Oxford Tavern and Dwyer's developments: Response to stakeholder letters

I refer to the RTA's letter dated 1 February 2008 and the Wollongong City Council's letter dated 29 January 2008 regarding concerns with the concept plan and major project application for the above two sites. In response to the issues raised in these letters, PB has prepared the following information.

Figure 1 Practical absorption capacity at unsignalised intersections.

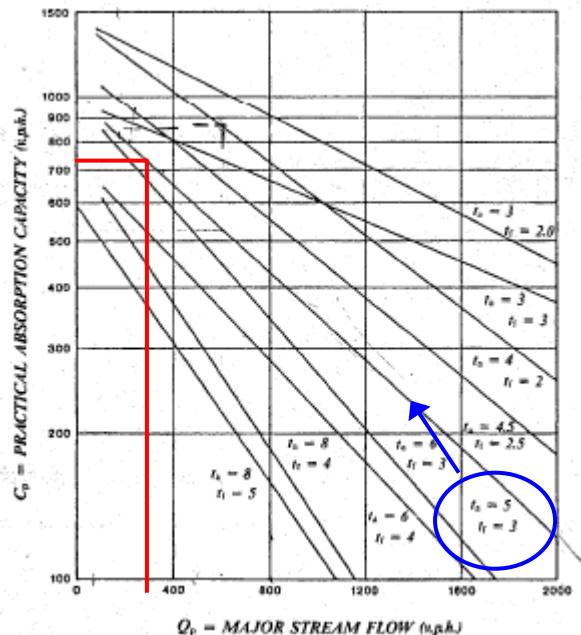
Austroads (2008) describe a *practical absorption capacity* as the capacity of a major stream of traffic (ie. Burelli Street) to absorb a minor stream of traffic (ie. the Porte Cochere entering traffic) based on (i) the available residual capacity of Burelli Street and (ii) the gap acceptance requirements of the Porte Cochere traffic required to enter the Burelli Street. The graph in Figure 1 allows for the derivation of the practical absorption capacity of a major traffic stream for different gap acceptance requirements.

The t_a and t_f values correspond to the *gap acceptance* and *follow up headways* for each type of entering movement. A conservative 5 second gap acceptance (t_a) and 3 second follow up headway (t_f) were adopted for the traffic that would egress from the Porte Cochere to enter (be “absorbed into”) the Burelli Street traffic. This graph indicates that for the highest case Burelli Street flow of 293 vehicles per hour, there would be a practical absorption capacity of more than 700 vehicles per hour. That is, with the available residual capacity of Burelli Street, and accounting for the gap acceptance requirements of the Port Cochere egressing traffic, more than 700 vehicles could enter from the Porte Cochere into the eastbound traffic lane of Burelli Street. As this absorption capacity greatly exceeds the “kiss and ride” transaction capacity of 150 vehicles per hour, it would be very unlikely that there would be any queuing, or queue spillback from the Porte Cochere. As such, the risk of traffic queuing back into the Burelli Street/ Corrimal Street intersection as a result of the Porte Cochere would be minimal.

Figure 2 Turning path assessment for a 5.2m passenger vehicle entering the Porte Cochere

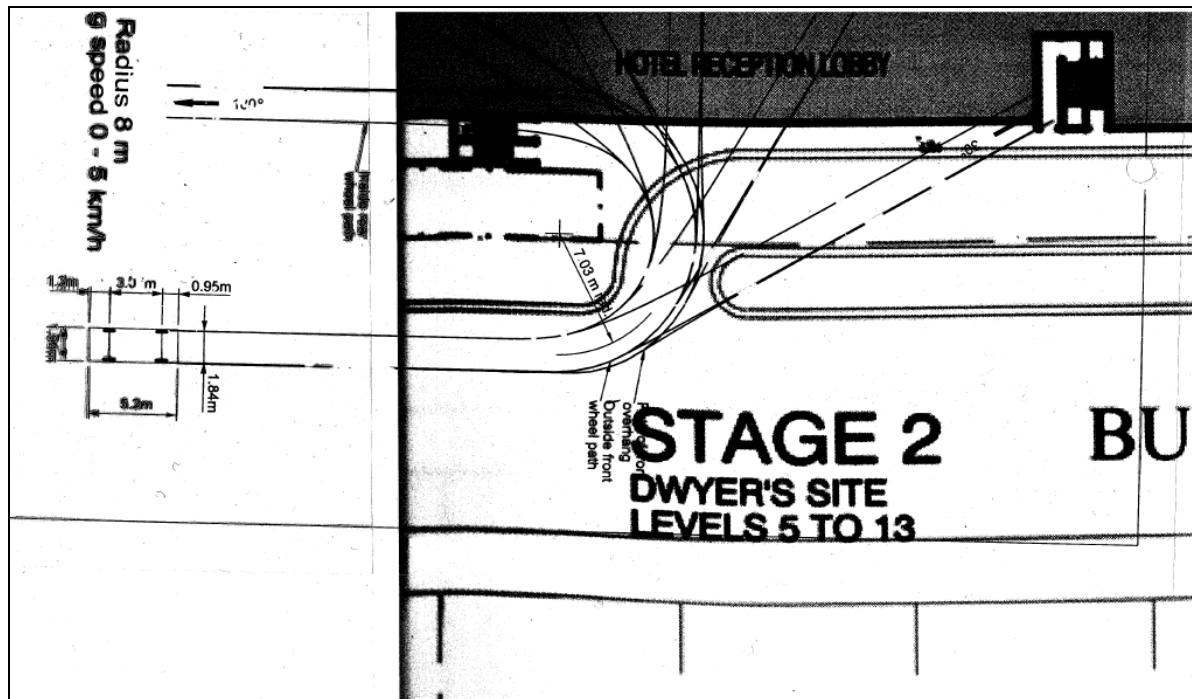
The Porte Cochere will only allow light vehicle access and signposting would be installed to this effect. In this regard, all turning paths for the entry and exiting movements by a 5.2m passenger vehicle have been checked and found to be adequate. As an indication, Figure 2 below shows the entering turning path of a 5.2m passenger vehicle at a design speed of 5km/h. The turning template used is an Austroads approved version.

Figure 5 Turning path assessment for the Corrimal Street/ Crown Street intersection.

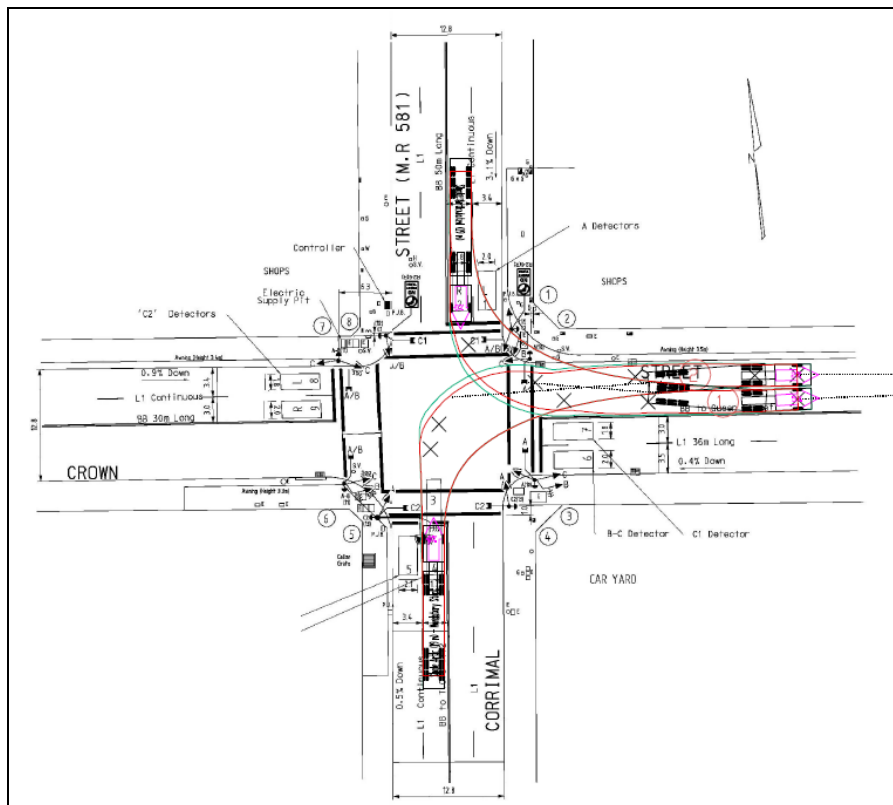
As requested, PB has completed a turning path assessment for all turning movements required by a 19m semi-trailer to access and egress from the proposed loading facility at the Dwyers site. This includes turning movements at the Corrimal Street/ Crown Street and Corrimal Street/ Burelli Street intersections. These have been shown in Figures 5, 6 and 7. The design tracking speed in all cases was 5 km/h.

The turning path assessment demonstrated that all turning movements into and out of the loading dock area by 19m semi-trailers would be achievable without encroachment over the centrelines of Crown and Burelli Streets and without encroachment over property lines.

The right-turn movement from Corrimall Street to Crown Street, and from Burelli Street to Corrimall Street would also be possible from the right-turn lane. These movements would not result in any illegal encroachment across centrelines or lane lines, and could be achieved without impact to side structures. It is noted that the Australian Road Rules were recently clarified in this regard.

The turning path assessment indicated that the left-turn movements from Corrimal Street to Crown Street, and from Burelli Street to Corrimal Street would not be possible without encroachment over the kerb line. As the kerb area would accommodate traffic signal structures and pedestrians waiting to cross the road, this is not considered acceptable. As such, PB recommends that the following management measures be considered:

- realignment of the kerb lines with minor widening of the intersection
- banning of left-turn movements by trucks and the development of a traffic management plan (TMP) to detail the required access and egress conditions for heavy vehicles accessing the Dwyer site.
